**COOLING TOWER REPLACEMENT
61 WOODLAND STREET
HARTFORD, CONNECTICUT
PROJECT: BI-2B-272 (2nd Rebid)**

ADDENDUM NUMBER 2

OCTOBER 22, 2010

SKA-01

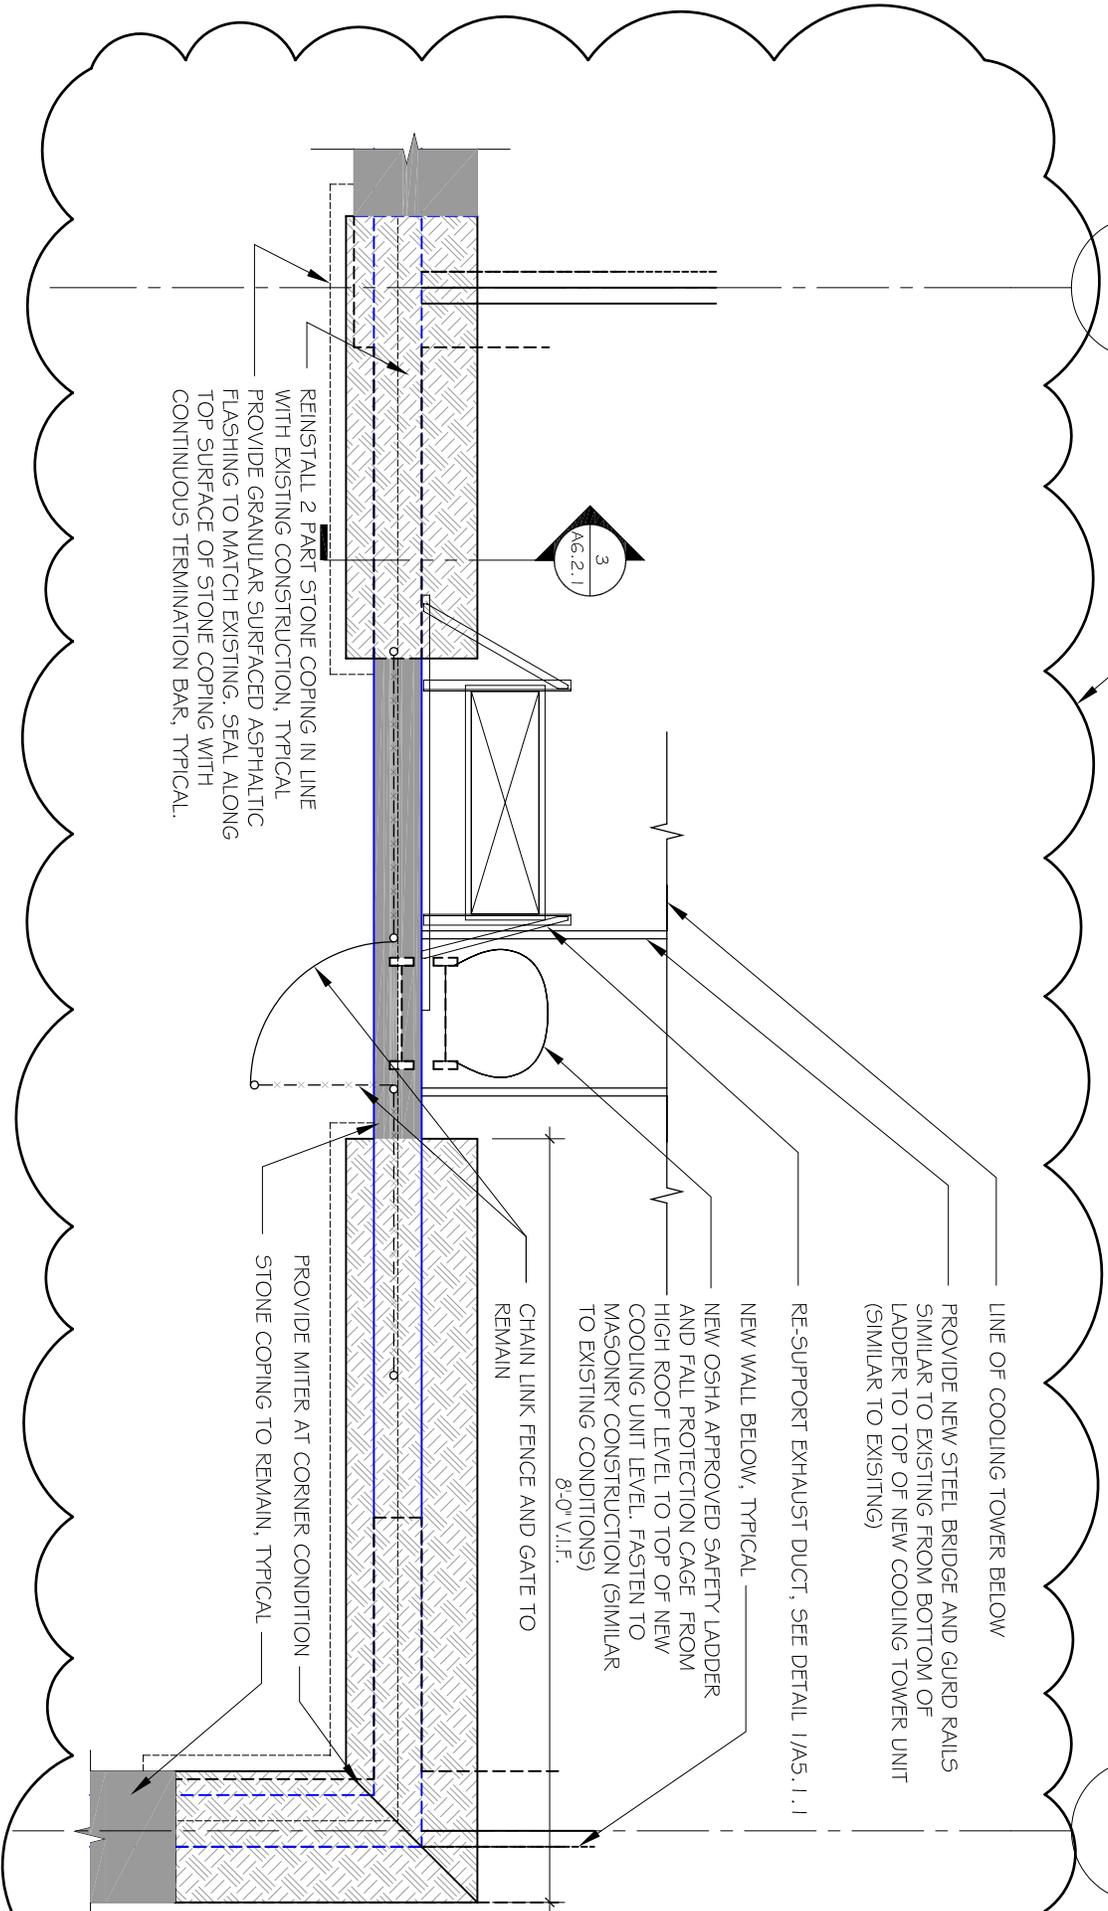
Drawing A2.6.2: REPLACE Detail 2/A2.6.2 with Sketch SKA-01

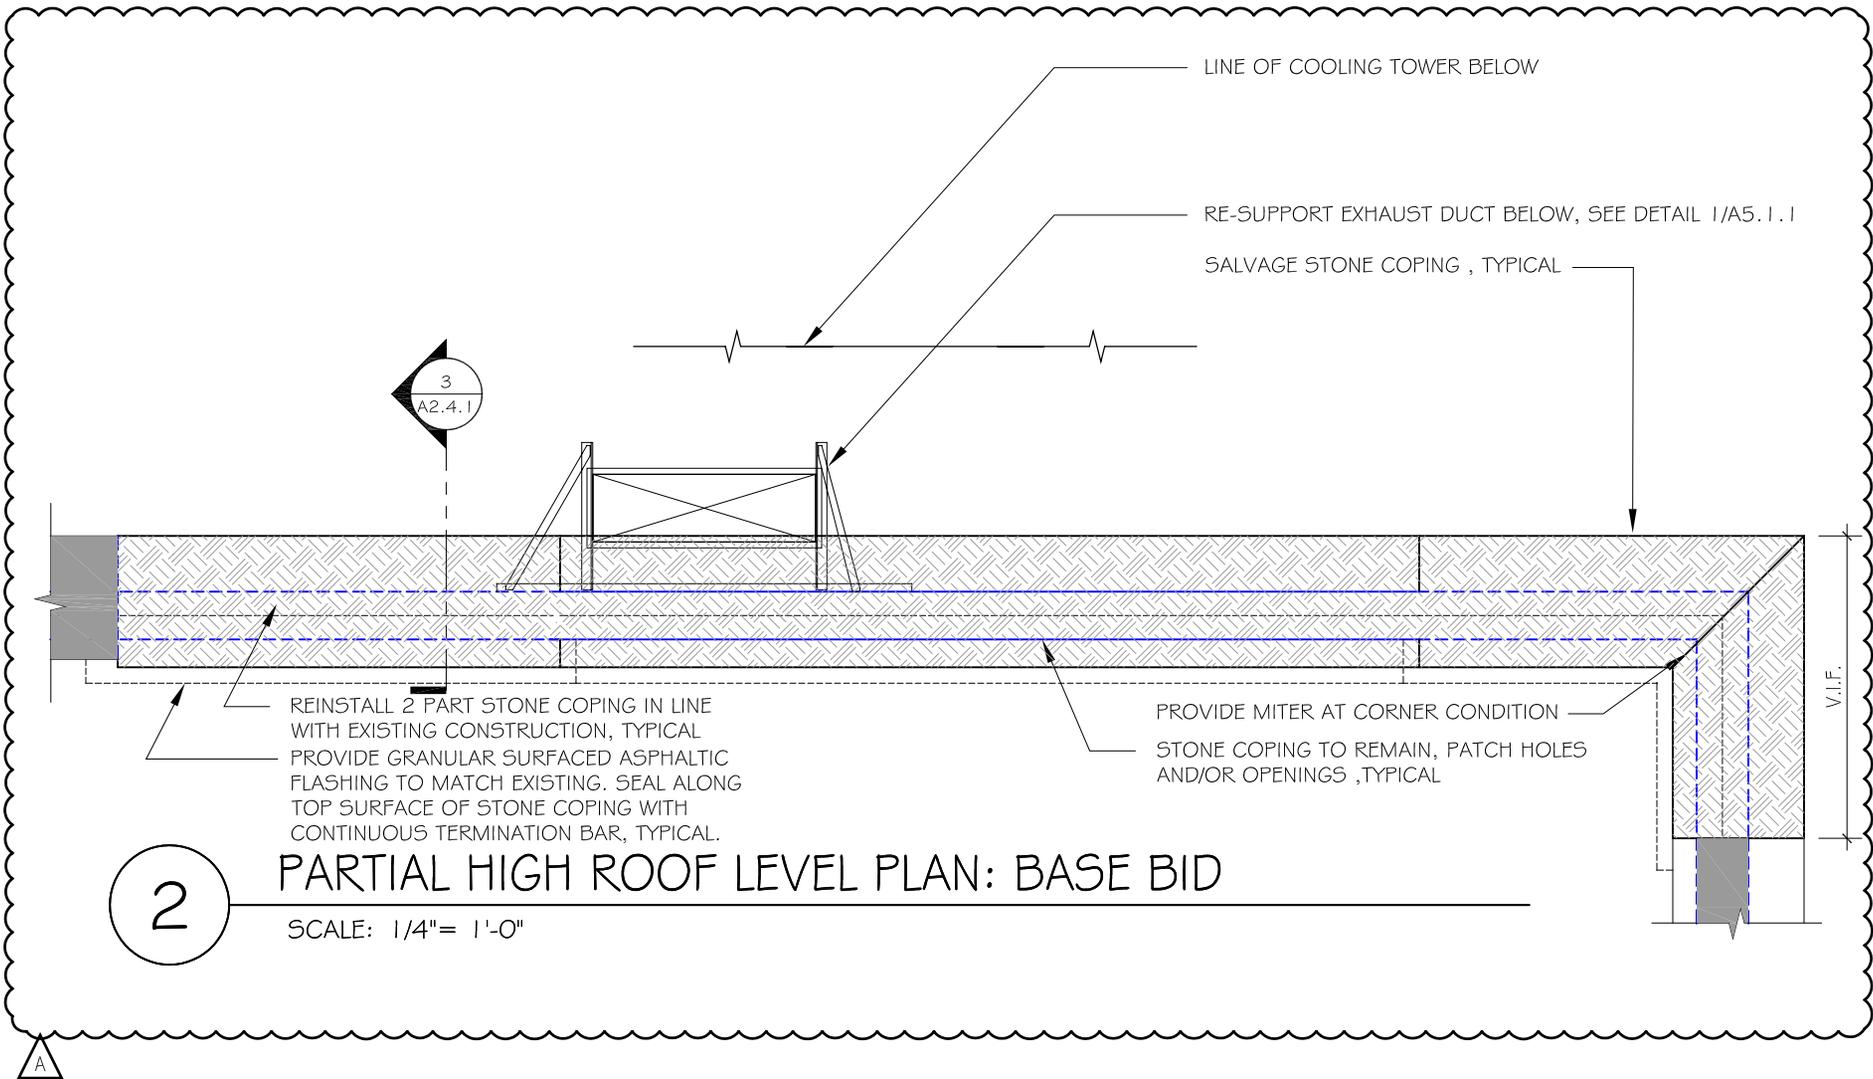
Drawing A2.4.1: REPLACE Detail 2/A2.4.1 with Sketch SKA-02

DRAWING TITLE:	WEST ELEVATION (SUPPLEMENTAL BID 01)	DWG. NO:	SKA-04	DATE:	10/27/2009
		PROJECT:	COOLING TOWER REPLACE'T 61 WOODLAND STREET HARTFORD, CT 06105	SCALE:	1/4" = 1'-0"
RE: 1/A6.3.2				JOB NO:	BI-2B-272 / CT.58.AR
				REVISED:

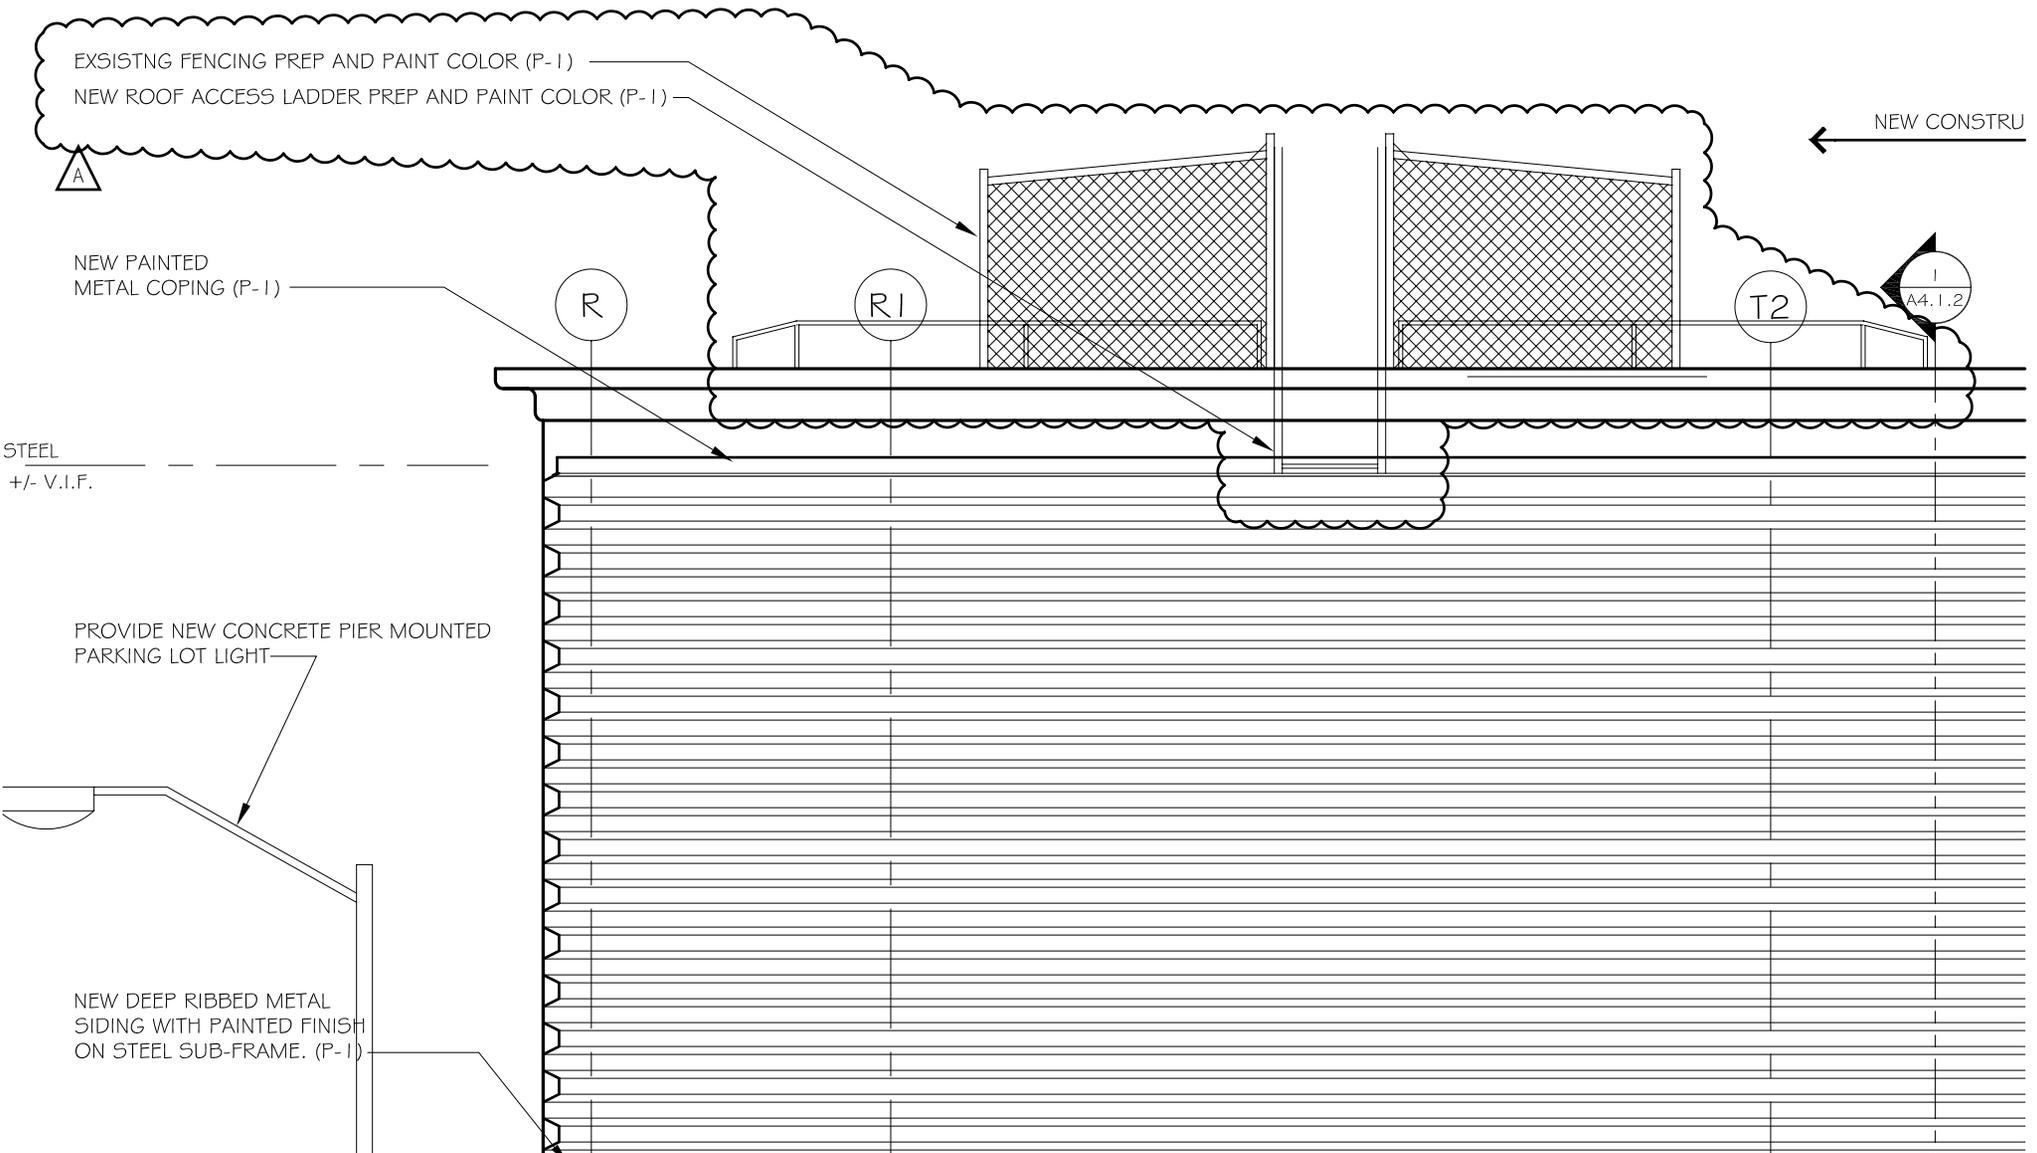
Drawing A6.3.2: MODIFY West Elevation with Sketch SKA-04
